## REQUEST

Current Zoning: R-5 (single family residential)  
Proposed Zoning: UR-1(CD) (urban residential, conditional)

## SUMMARY OF PETITION

The petition proposes to allow a single family detached home and a duplex on a vacant parcel.

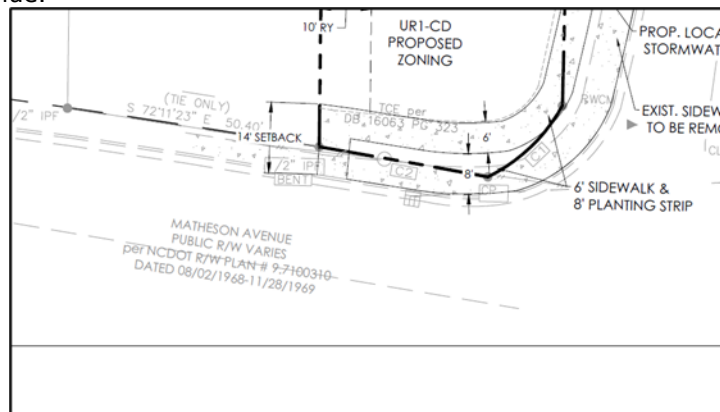
1. ~~Curbline: The proposed zoning district has a setback measured from back of the existing or proposed future curbline.~~
  - a. ~~Matheson Avenue: Curb and gutter to be 27 feet measured from centerline to back of curb.~~

~~Label and dimension existing curbline location on site plan measured from centerline of Matheson Avenue.~~

2. ~~Revise site plan and conditional note(s) to commit to dedicate 40 feet of right-of-way along Matheson Avenue measured from the road centerline. The site plan shall label and dimension the right-of-way from the road centerline.~~

3. ~~Revise site plan and conditional note(s) to commit to construct an 8-foot planting strip, and 6-foot sidewalk on Matheson Avenue and Pinckney Avenue per Chapter 19. The site plan shall label and dimension both items from the back of curb and gutter. Add streetscape commitments to conditional notes section of the Rezoning Plan.~~

4. ~~Revise site plan and conditional note(s) to show proposed intersection and frontage improvements of Matheson Avenue Road Conversion project project that is being done by the City's CIP project. These improvements can be shown as "by others" and in grayscale. The project scope includes converting Matheson Avenue from 4 lanes to 2 lanes, construct raised 2-way cycle track on south side of Matheson Avenue. These improvements to be coordinated with General Services and CDOT during the permitting process.~~

5. ~~Remove CDOT Notes from site plan.~~

**5. TRANSPORTATION**

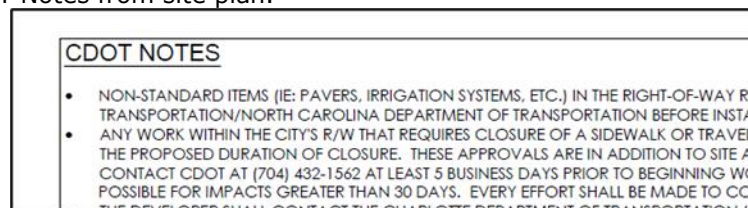
6. ~~Revise conditional note 5.A) by replacing NCDOT with CDOT as Pinckney Avenue is City-maintained.~~

A) VEHICULAR ACCESS WILL BE AS GENERALLY DEPICTED ON THE REZONING PLAN. THE PLACEMENT AND CONFIGURATION OF THE VEHICULAR ACCESS POINT SHOWN ON THE REZONING PLAN IS SUBJECT TO ANY MINOR MODIFICATIONS REQUIRED TO ACCOMMODATE FINAL SITE AND CONSTRUCTION PLANS AND DESIGNS AND TO ANY ADJUSTMENTS REQUIRED BY NCDOT FOR APPROVAL.
